Dear customer,

Thank you for placing a price offer with Eurocircuits. While analyzing your data to prepare the offer, our engineers have found some manufacturability issues that require your attention. These are listed below. Wherever possible we have proposed a solution. This may mean changing the technology parameters of the offer details to the values found in the data.

1. Please check: Your order is for single PCB with Assembly service

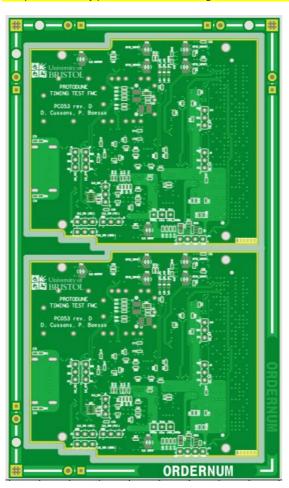
You have ordered this as a single PCB with Assembly service for it.

Implemented Solution:

For optimal assembly production we have changed the order details from Single PCB to a PANEL. Refer below image:

We have changed the order detail parameters and recalculated the price accordingly.

We have also selected the option "No border - Single PCB" in the order details. It means that you will get Single PCBs delivered after production.

9. Action Required: Footprint Defined in the BOM Does Not Match the Gerber Data

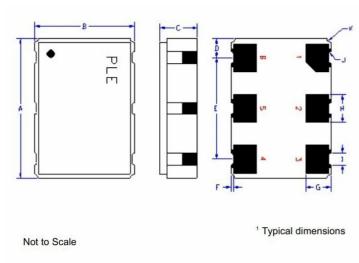
Our engineers have found that the footprint for the following reference designators as specified in your BOM do not match the gerber data. Either the footprint used during PCB layout is incorrect or manufacturer part numbers given in BOM is incorrect.

IC14, IC16 QZ1

Requested action

Please provide us with the correct Manufacturer part numbers as per PCB layout.
